Colorado Division of Reclamation, Mining and Safety  
1313 Sherman Street, Room 215  
Denver, CO 80203

**Objections to Permitting Hitch Rack Ranch Quarry**  
**Permit Number M-2016-010**  
Ms. Amy Eschberger Lead Specialist

Prepared by Jerry P Moore  
15836 Spanish Peak Vw  
Colorado Springs, CO 80926  
832-875-7030  
832-875-7020

FIGURE A

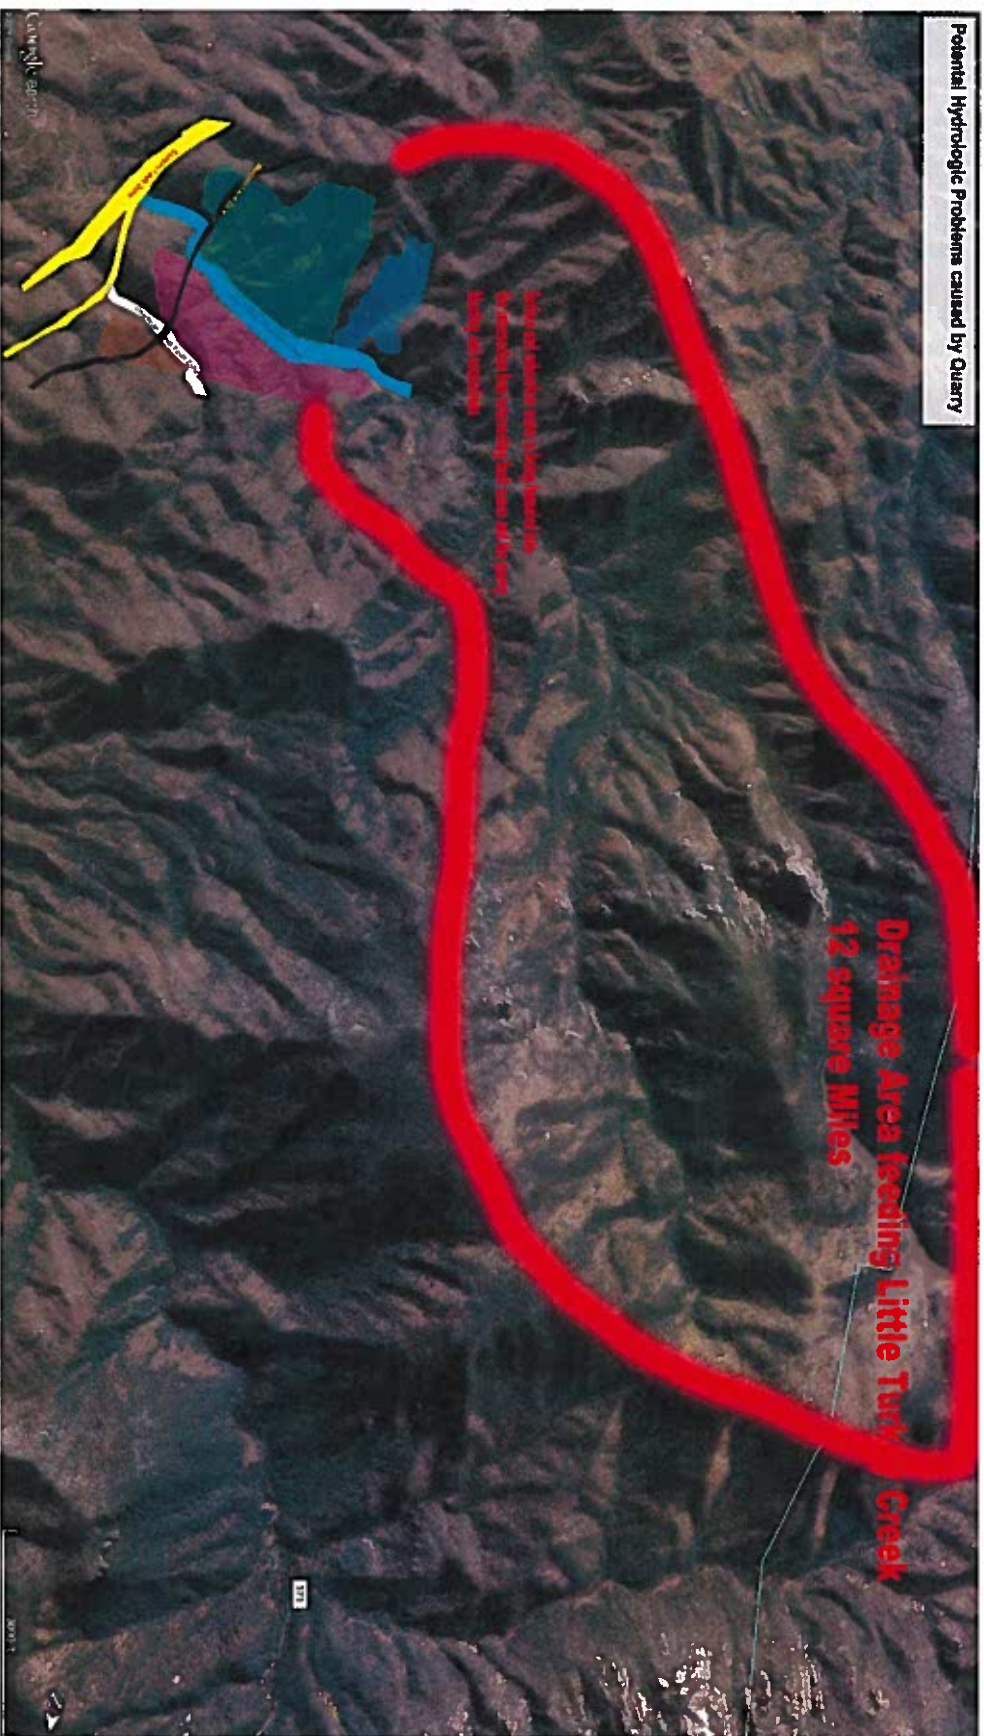
- The billion-plus years of almost continuous structural deformation and uplift surrounding the Pikes Peak batholith has created an area of fractured rock and a very faulted terrain.
- The proposed area to be quarried is at the intersection of major faults and aquifers in fractured rock.
- The ground water recharge and surface water is funneled through a canyon that narrows to 300 feet when entering the quarry.
- The flow through the quarry is in and below the Little Turkey Creek creekbed and alluvium. Based on Transit Mix coring, this is a highly fractured fault zone. Deadman Creek has the same situation, with drainage through the quarry in a highly faulted creekbed.

- Based on my experience and the information available on Front Range aquifers, with this degree of fracturing and faulting the surface and ground waters are going to be in communication.
  - In the Pikes Peak granite almost all effective permeability and porosity will be provided by fractures. The amount will vary depending upon the amount of stress and weathering. To some degree this should be true for all the aquifers in the quarry site.
- The intersection of the creek bed fault zones and the thrust faults in these fractured rock aquifers should **not** provide an effective aquitard.
  - If the thrust faults are “sealed” it is very doubtful that sealing would be continuous
  - The fault planes are as likely to provide a conduit as a barrier.

In the setting detailed above and with the removal of 393 acres of material with blasting it is **impossible** to predict that ground water and surface water flow, and therefore aquifer recharge, will not be significantly altered. These changes could cause the stoppage or reduction of the ground water supply to residents.

**Figure B**  
***Transit Mix Geology Interpretation***

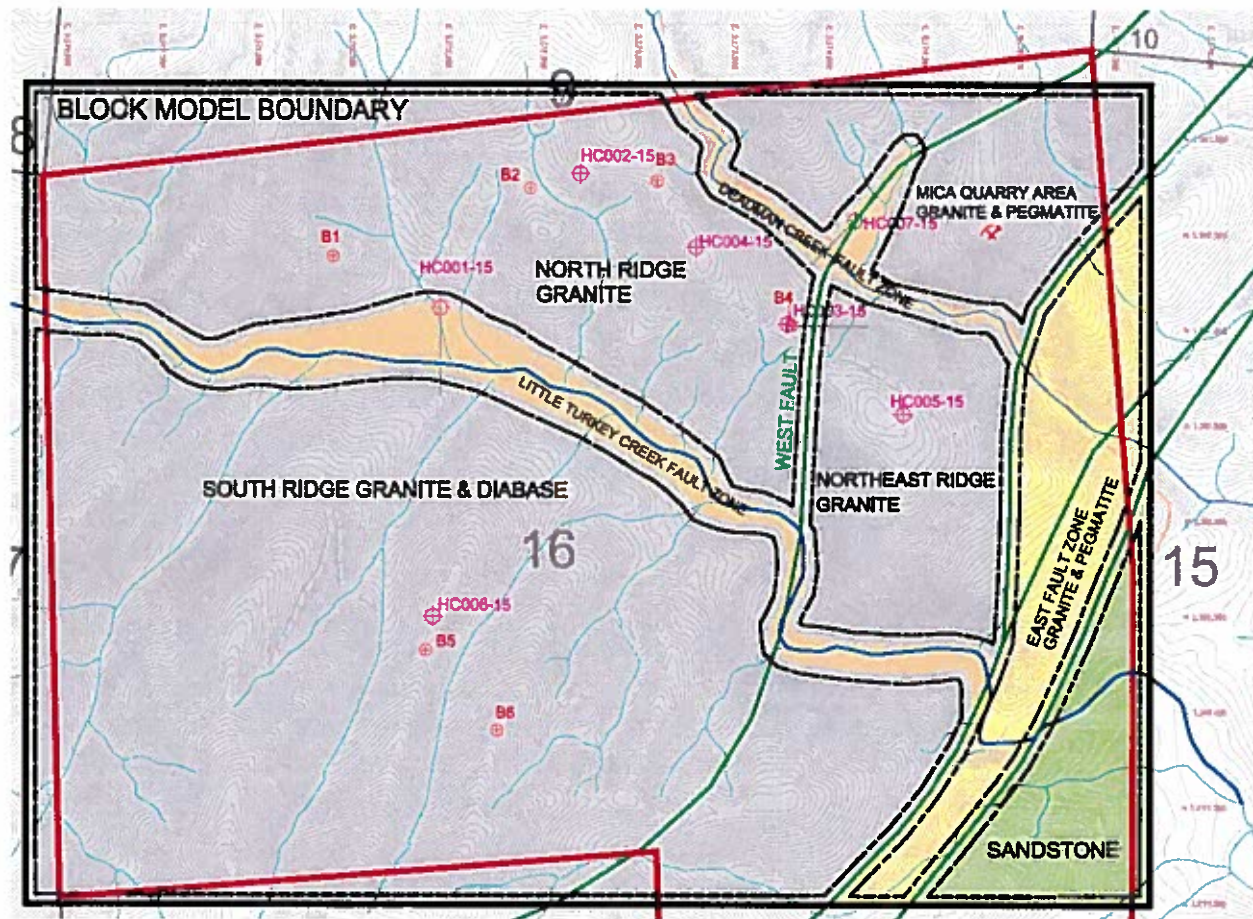
*The test coring was done using water based mud in a highly fractured zone. This makes the statements about "highly productive aquifer zones not encountered", "no ground water interception", and "probably not impact surface or ground water systems" a guess based on easily misinterpreted data.*

*The 100 foot lateral and 10 foot vertical separations are not sufficient aquitards in this structural setting to support the statements that I have highlighted in the above paragraphs. Fractured crystalline rock sitting on highly brecciated faulted creek beds that intersect with a regional thrust fault system make the effectiveness unpredictable. Also, after blasting and removal of 393 acres of granite, it is possible that communication may be created between isolated aquifers if they were not already.*

*In this structural setting, where the hydrodynamics of the surface and subsurface are probably connected to some degree, you cannot make statements like the above with any degree of certainty.*

*With the blasting in this fractured and faulted area it is impossible to state as fact that the discharge will all continue to drain into Little Turkey Creek.*

*There is insufficient geologic information to know specifically the source of the water produced by the wells in the vicinity and west of the mine. It is possible that the alluvium, sandstone, crystalline fractured granite, and brecciated fault zone are all connected by fractures and faults.*
